CITY OF PORTLAND BUILDING PERMIT

PERMIT ID: 2013-00076

37 CARROLL ST

has permission to **Renovate kitchen & bathroom; replace windows, etc. Convert screen porch to mudroom/pantry.**

PANTRY SECTION A

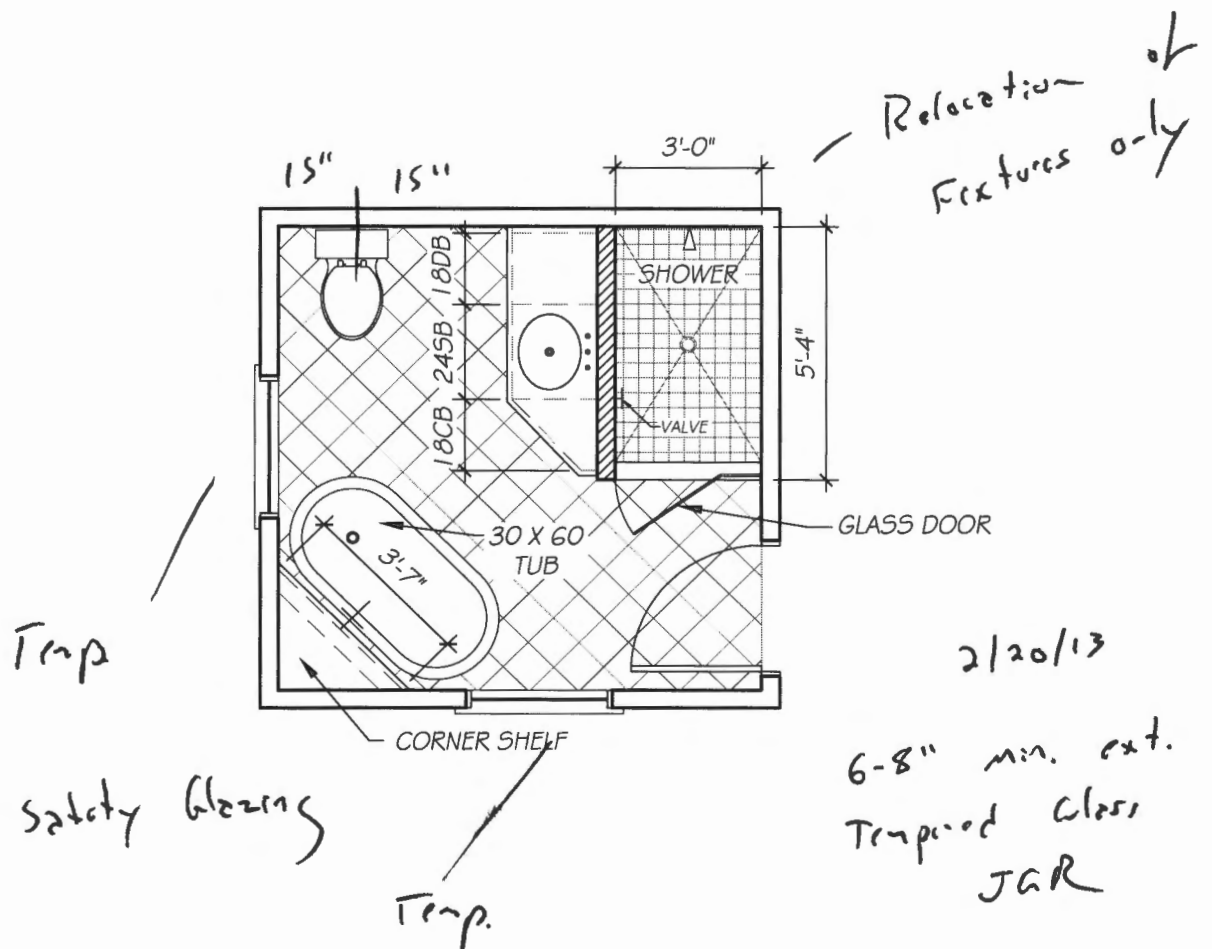
- 1) Separate permits are required for any electrical: plumbing, sprinkler, fire alarm, HVAC systems, commercial hood exhaust systems and fuel tanks. Separate plans may need to be submitted for approval as a part of this process.
- 2) Permit approved based on the plans submitted and reviewed w/owner/ contractor, with additional information as agreed on and as noted on plans.
- 3) Note: Spoke with Contactor, she will assess the bearing points for the proposed interior LVL beam once the walls studs are exposed. Modifications may be required including foundation footings.
- 4) The design load spec sheets for any engineered beam(s) / Trusses must be submitted to this office.
- 5) Ventilation of this space is required per ASRAE 62.2 , 2007 edition; Contractor agreed that the "building envelope" insulation will comply with the IECC, 2009 (Maine State Energy Codes).

FIRST FLOOR PLAN

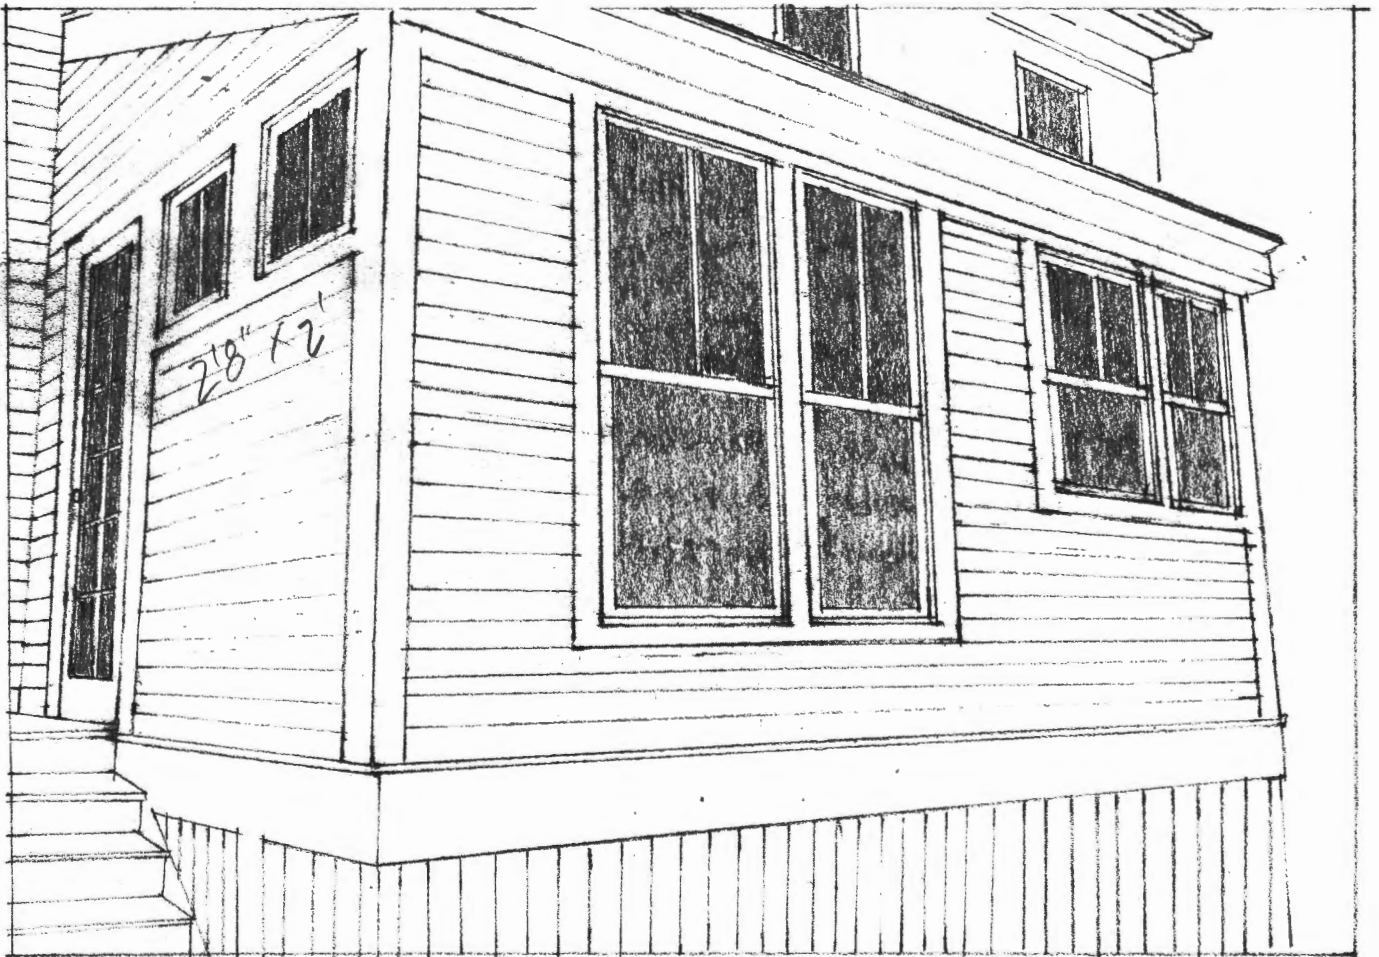
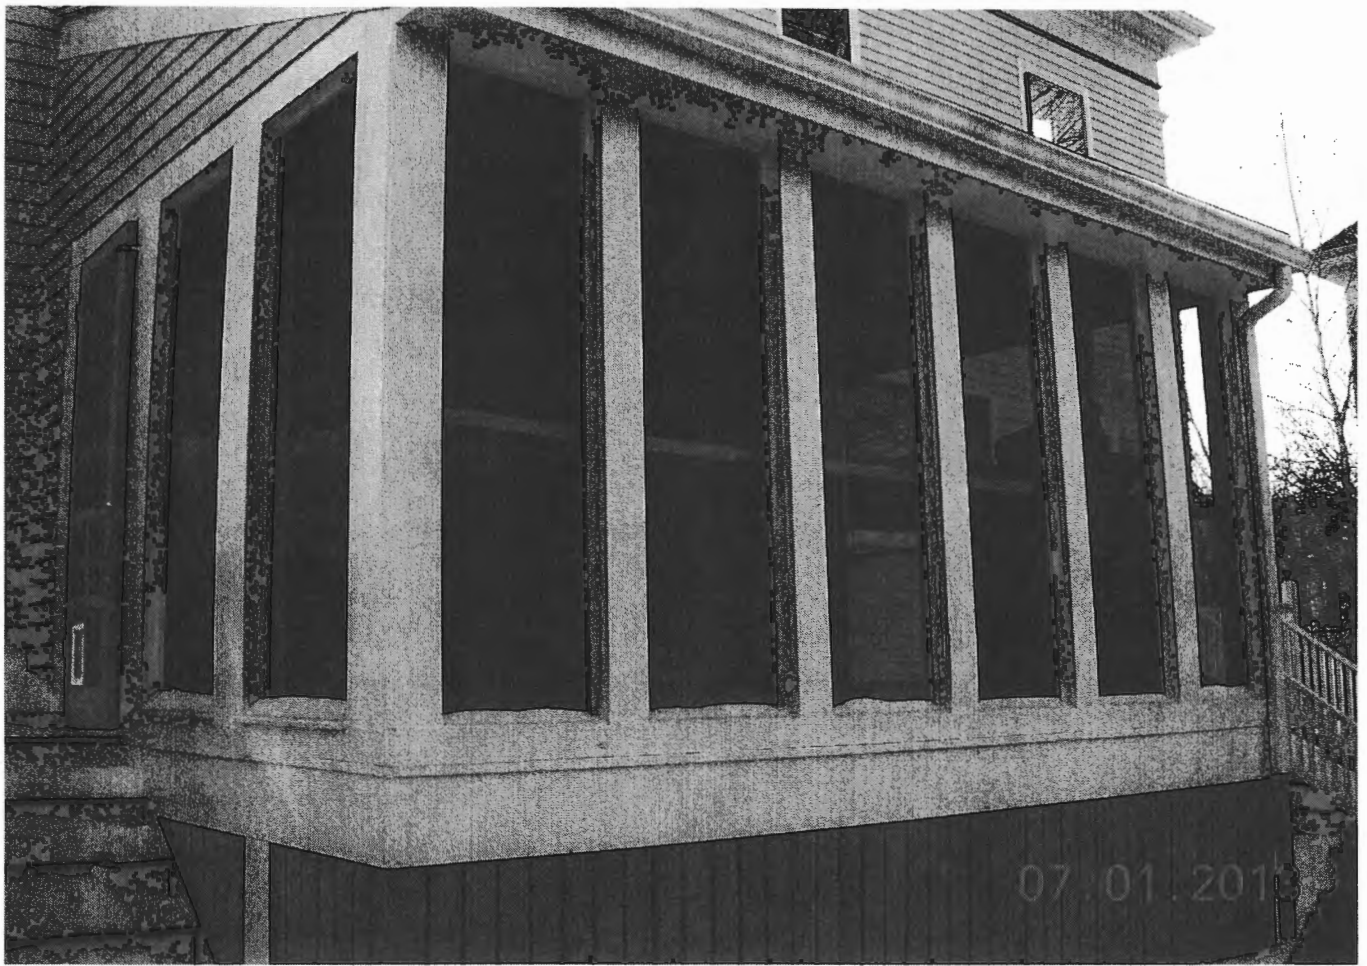
- 8) 8. The two awning windows shown on the east wall of the mudroom in the 2/6/13 revised plan are to match the wood windows manufactured by Windsor which are approved to be installed in the main part of the house. (All windows visible from a public way are to be of the same type, configuration, and material - wood.)

Contractor sh. she will add Smoke Alarms & CO in renovated "required areas".

A (2) or (3) 2x8" headers will be used for the window openings

meeting 1A-427
